**Interim Panel Report**

**Melton Planning Scheme Amendment C162**

**Mount Atkinson and Tarneit Plains Precinct Structure Plan**

**7 November 2016**

Figure 1 Precinct features showing the location of buffers and easements

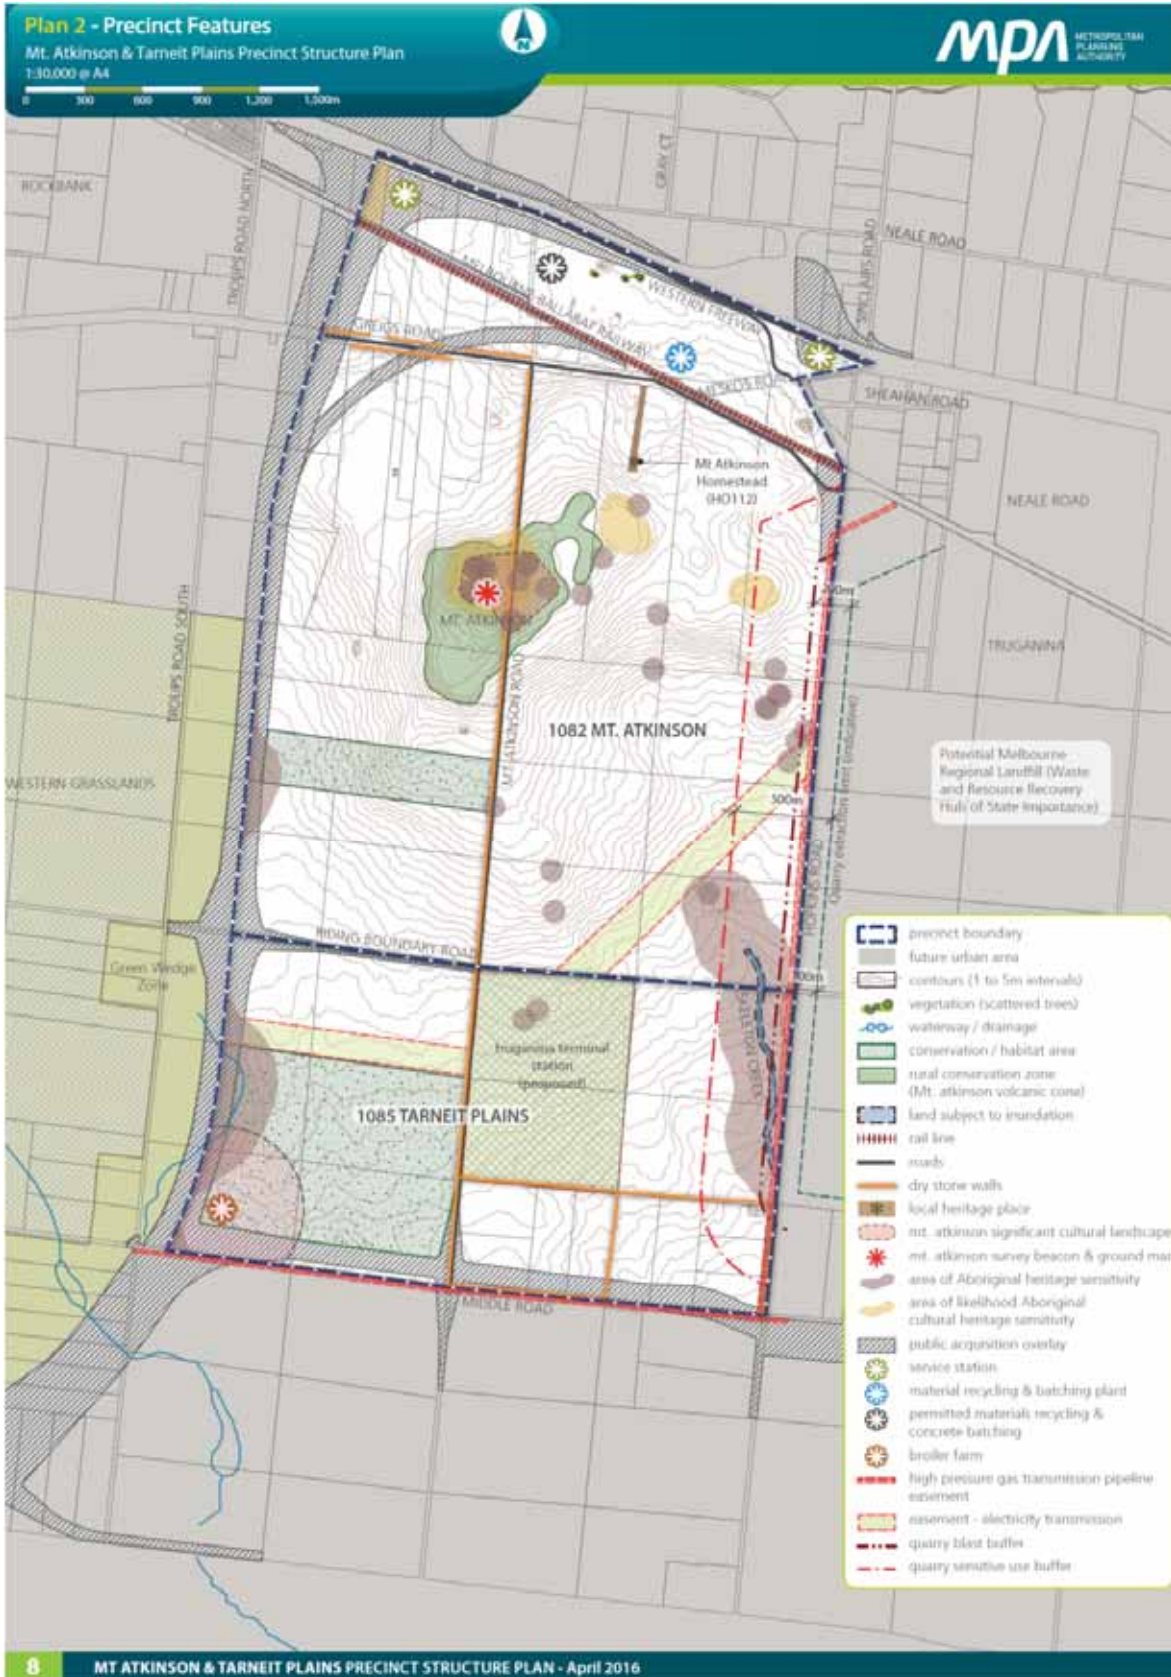
- the gas pipelines and their measurement length constitute a “*barrier to development*”, and as such should be shown on Map 1 in the UGZ9
- the measurement length should be shown on Plan 2 (Precinct Features) in the PSP, as well as Plan 12 (Utilities).

The Panel agrees that it will improve the transparency of the controls to include the measurement length on Map 1 in the UGZ9, as the UGZ9 controls directly reference the measurement length. The Panel also considers that the measurement length, like the quarry buffers, responds to an existing feature of the precinct, and should be identified on Plan 2 in the PSP.

- a) Map 1 in the Urban Growth Zone Schedule 9
- b) Plan 2 (Precinct Features) in the Precinct Structure Plan.

Figure 2 Plan 12 (Utilities) from the PSP

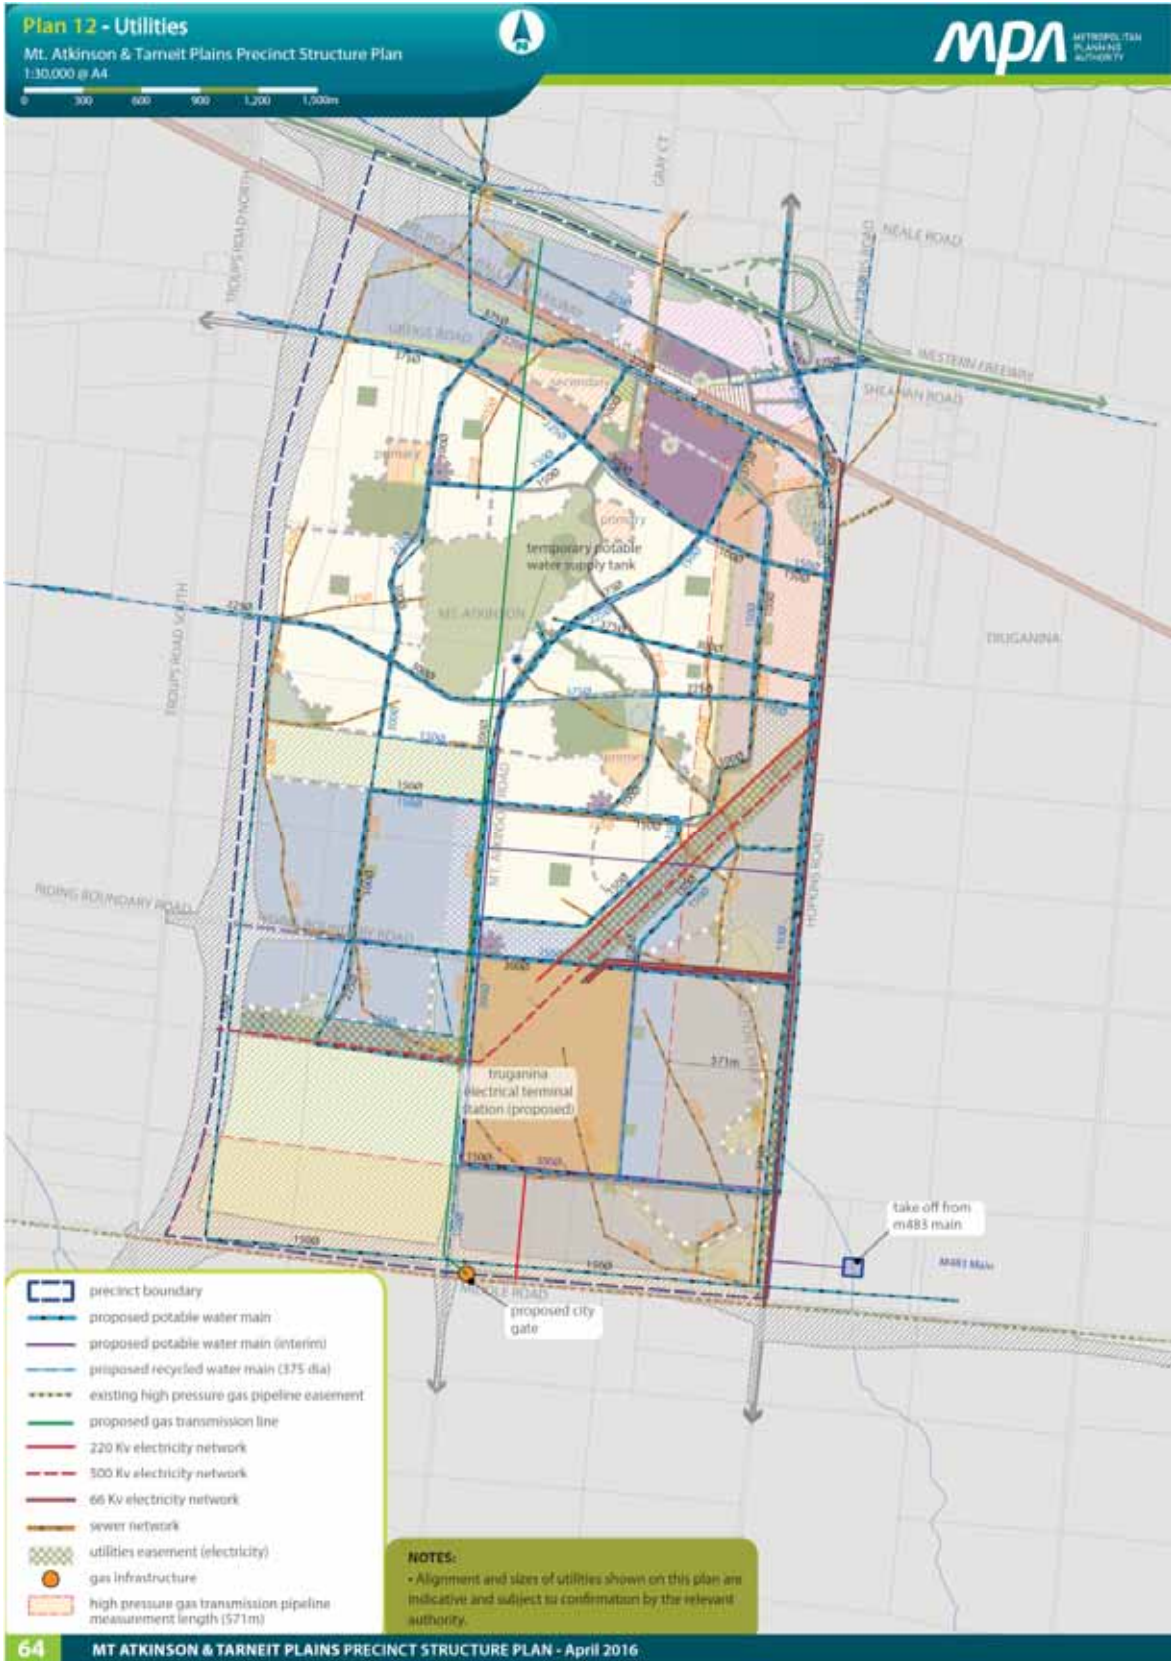
The pipeline easements, along with their measurement length, are identified on Plan 12 (Utilities) of the PSP (reproduced as Figure 2 below).

The exhibited Amendment already included a permit trigger for a number of sensitive uses in the measurement length, and the VPA agreed to add service station in response to APA's submission. The sensitive uses that remained in dispute were retail premises and accommodation.

APA submitted that retail premises are commonly identified as a sensitive use, as they include a wide range of uses involving persons who have different ability to manage and respond to risk events. APA indicated that including retail as a sensitive use was 'standard' within the planning system, and submitted that the Panel for the Donnybrook/Woodstock PSP had included retail as a sensitive use. The VPA did not agree. It submitted that retail, particularly large format retail, does not generally involve large congregations of people, and restricting otherwise as of right uses in a business/large format retail area would be counterproductive to facilitating development. Mount Atkinson Holdings (Submission 22) supported the VPA's position.

10. Amend Guideline G22 in the Precinct Structure Plan to add the following dot point:

- *Not be located in the high pressure gas transmission pipeline measurement length identified on Plan 12 (Utilities).*

Figure 3 Council preferred primary arterial cross section

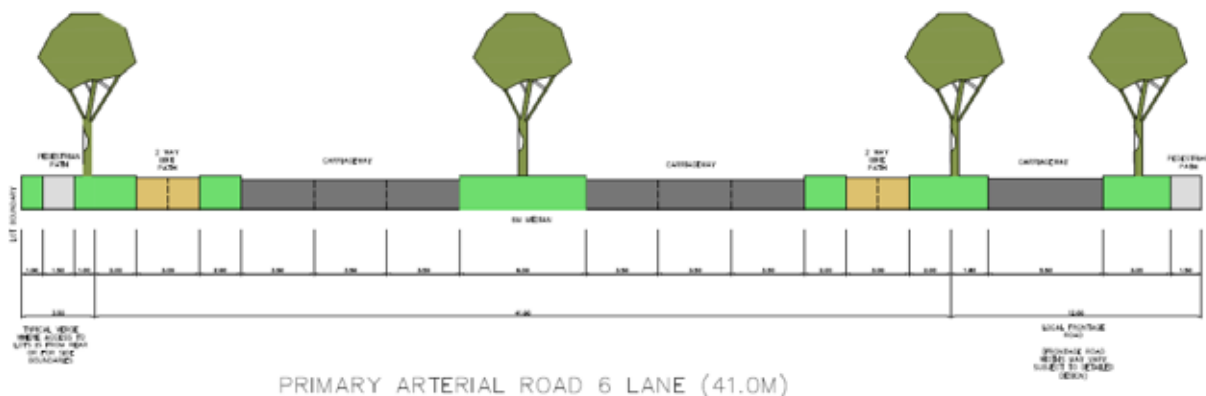
Council proposed a modified cross section for primary arterial roads which separates the two way bicycle path and the pedestrian path. The Council proposal is as shown in Figure 8 of Mr Pelosi's evidence and reproduced as Figure 3 below.

The VPA agreed with Council's proposal.

The Panel accepts that the agreed modified primary arterial 6 lane cross section is an improvement and should be adopted. This should apply to Road Section 7 in the PSP.
